City of Mississauga

City Department and Agency Comments

Date Finalized: 2021-01-13	File(s): A355.20 Ward: 6
To: Committee of Adjustment	
From: Committee of Adjustment Coordinator	Meeting date: 2021-01-21

Property Address: 1031 Lucerne Crescent

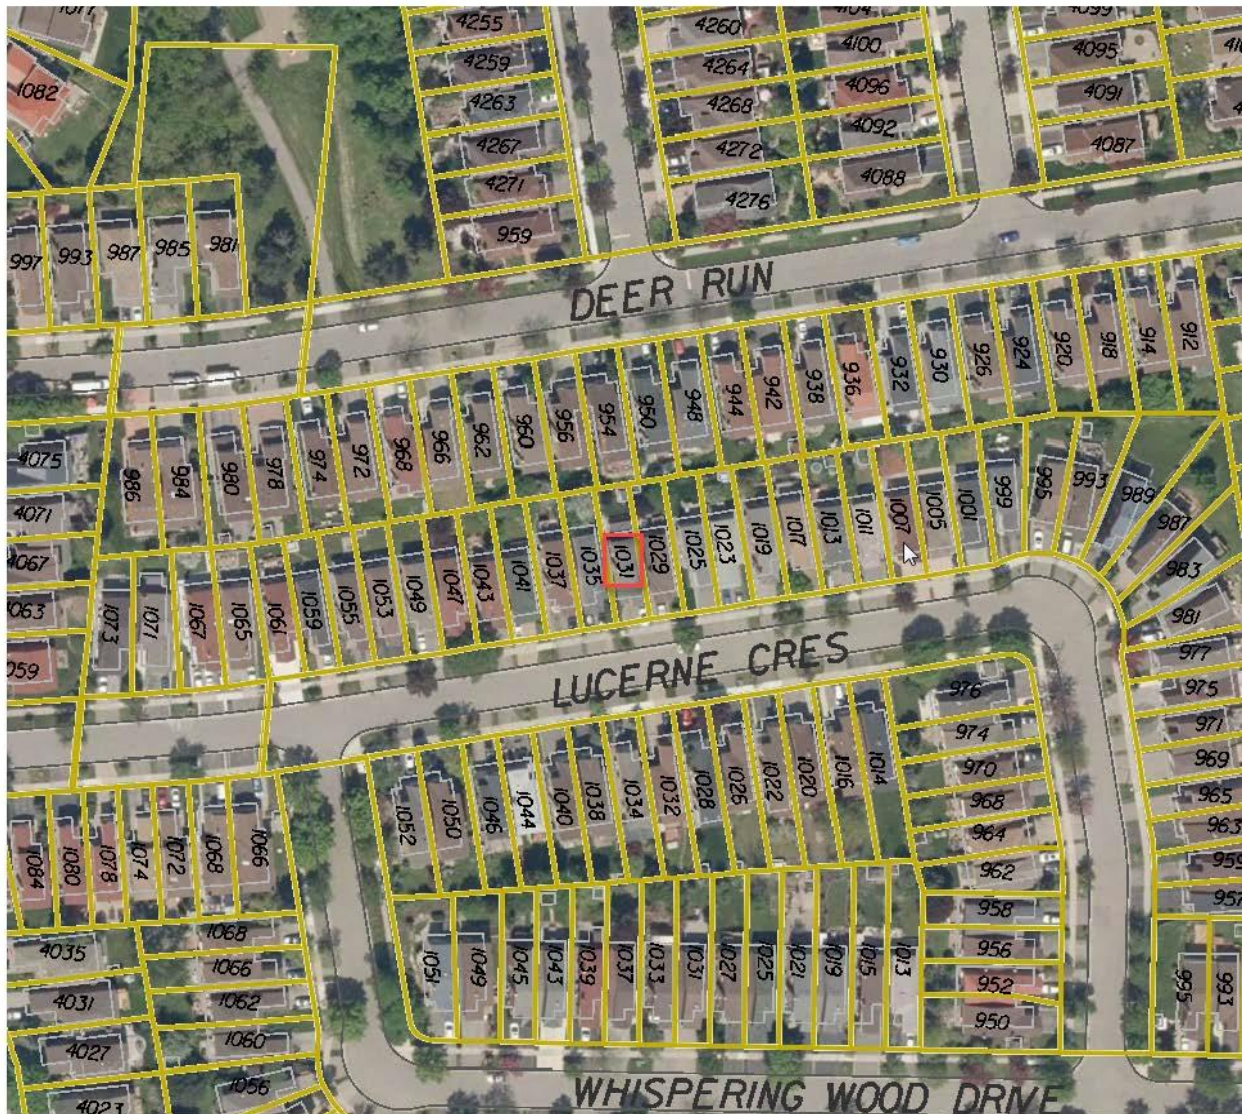
Zoning By-law 0225-2007

Zoning: RM2-4 - Residential
